December 5, 2008

Please find enclosed Intel comments and feedback on the Energy Star for Servers Specification Draft v3.0, dated 11/4/08.

Intel welcomes the opportunity to provide the EPA with the following response to draft 3 of the ENERGY STAR Program Requirements for Computer Servers v1.0 specification. The proposed rating system, testing plans, and initial dataset were helpful in understanding the direction and decisions the EPA has taken for this program. Based upon draft 3, we believe there are high risks and potential negative energy efficiency consequences with the current EPA proposal. These should be addressed to ensure the integrity and energy savings opportunities in the program. The comments listed below are specific to draft 3 and should be considered as additional to Intel's feedback on the previous drafts.

Figure 2. Histogram of EPA's 11/14/08 dataset

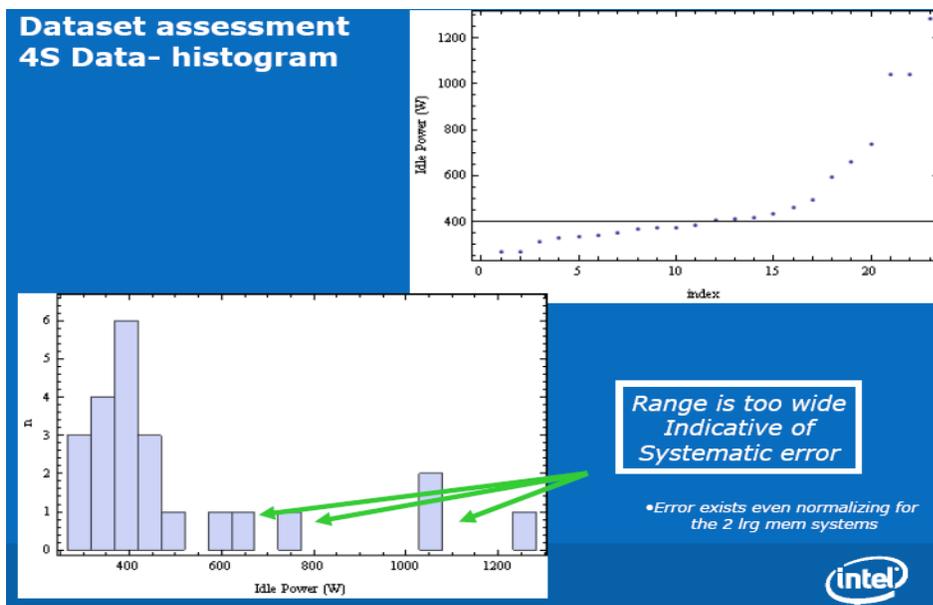
If EPA insists upon using the flawed approach of system idle power, the inaccuracies and deterministic trends in data set must be addressed before setting the limits. This is particularly true in the 4S configuration where the wide range of configuration options also drives a large range in idle power. The dataset indicates an explicit need to establish a baseline set of hardware configurations for each of the categories of systems (1S, 2S, and 4S).

- 1S
 - The proposed idle power limit may be artificially low due to the inclusion of what would normally be considered "small scale servers", per Energy Star computer specification v5.0. These form factors should not be included in setting the limits for the server energy star specifications.
 - Recommend that the EPA query 1P data submissions to ensure the data points are solely enterprise class servers
- 2S
 - Clarification requested- recommend that 2S standard should be $\leq 16\text{GB}$. Consistent with the data. Consistent with the architecture.
- 4S
 - Incorrect configurations:
 - Index 108 (142W) is a 2x 2S system
 - Index 109 (214W) OEM confirmed 1S was mis-labeled 4S
 - Index 112 (281W) has only 4GB system memory. EPA approved removal
 - Idle power targets for 4S should be reset based on corrections to the dataset.

A histogram of the existing dataset shows a skewed distribution and a trend analysis that is indicative of, but not conclusive evidence for, systematic trends in the data.

Alternative Statistical View of the Dataset

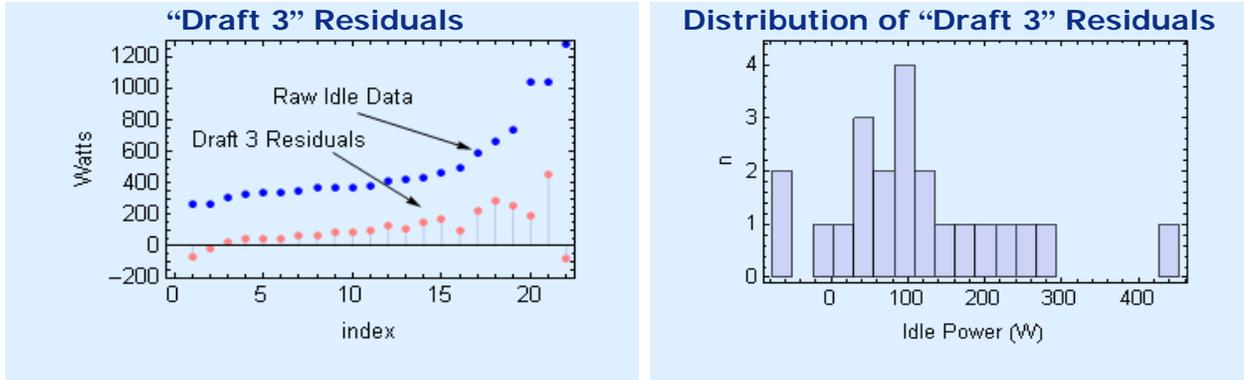
EPA's Draft 3 Formula "is based on observable trends in the dataset; and represents approximately 25% of models in the dataset, across all bins and system characteristics (e.g. # of processors and hard drives, installed memory, redundancy level, etc.)."

The analysis shows the "residuals" based on the EPA Draft 3 factors for memory and HDD.

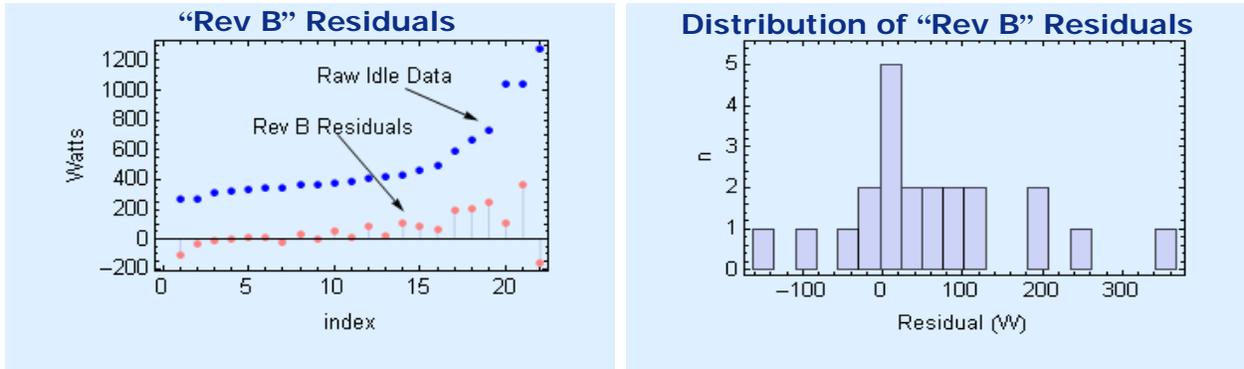
It is clear that the residuals still exhibit strong systematic trend, suggesting potential "hidden" variables. The skewed shape of the distribution (corrected) is still strongly skewed.

We conclude that Draft 3 (formula) does not fully reflect observed trends.

The Rev B formula, whose results are shown in the figure above, use EPA's methodology and retains the proposed allocations for HDD and Memory, but includes an allocation of 22W per PSU.

The PSU parameter falls out of the data quite naturally. The fit parameter of 22.1 W has a calculated error of less than 2%. This indicates at least one additional trend the data which should be corrected.

Based on the residual analysis above, we believe other systematic factors are present in the data. Unfortunately they could not be adequately analyzed because the data on system configurations was not available. We believe a corrected idle power spec for 4S systems would account for these additional factors.
